ADA Curb Ramp New Construction Inspection Form (Combination)

NW 307th

23886.56

NW Pacific

COMBINATION RAMP (C)

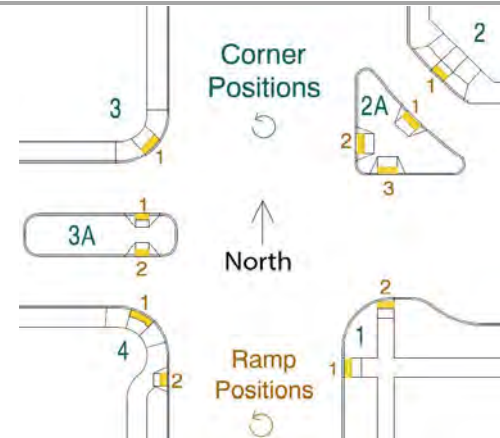
TD not full width, more than 2", RR3-CRK
